Apartment 3 chateau du Rocher

PROJECT: Apartment 3, Chateau Des Roches, Le Mont Gros D'Acou, St. Brevin, Jersey, JE3 8ED

TITLE: CURTAINS & BLINDS

DRAWING NO: 00 REVISION: A- 09/09/25

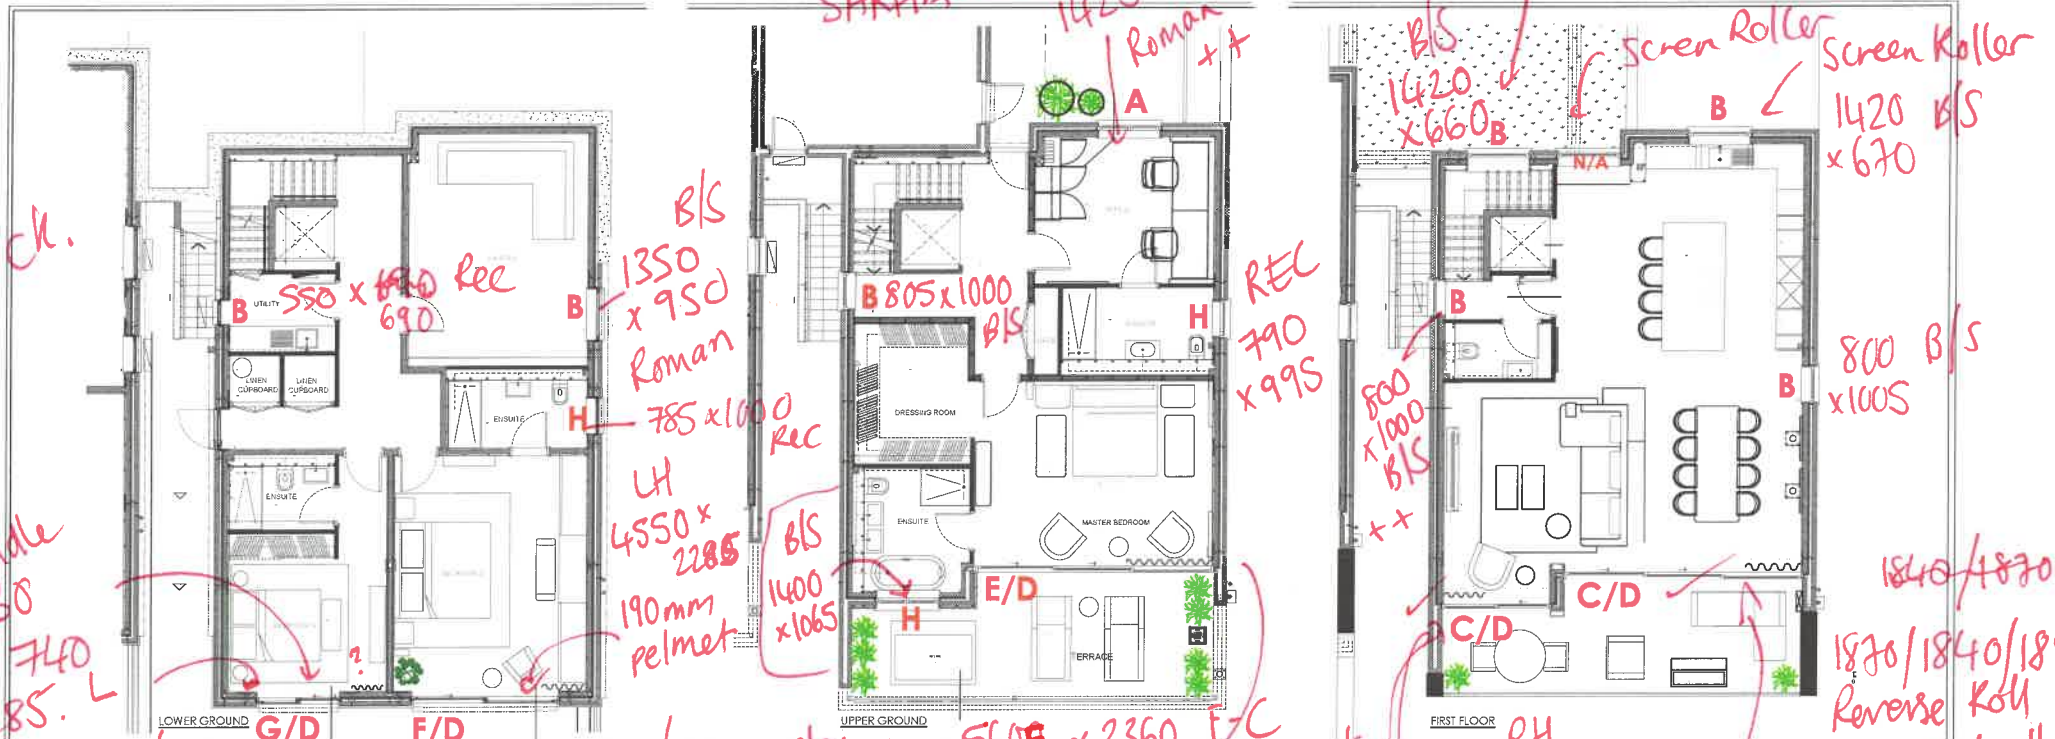
07797 777000 SARHA - 1425 x 1020 BS Roman + #

SG track.

Middle 1930 + 740 + 2285. L

960/950 x 2050 NOTE: BEDROOM 1 & 2 TO HAVE NEW PLASTER BULKHEAD TO CONCEAL TRACK 1720/1735 x 2050

BLS box → 5605 x 2360 F-C 1880/1820/1900 x 2360 R/R BLS 1235/1245 x 2260

800 B/S x 1005 1840/1870 1870/1840/1890 Reverse Roll 95mm depth x 2260 RH

GRAVITY DISCONTINUED SUNWOOD faux wood

5950 TW LH x 2360 F-C
 2490 TW RH

x # Romans +200 + 150 | Email Dan - do not put power for curtains + blinds.
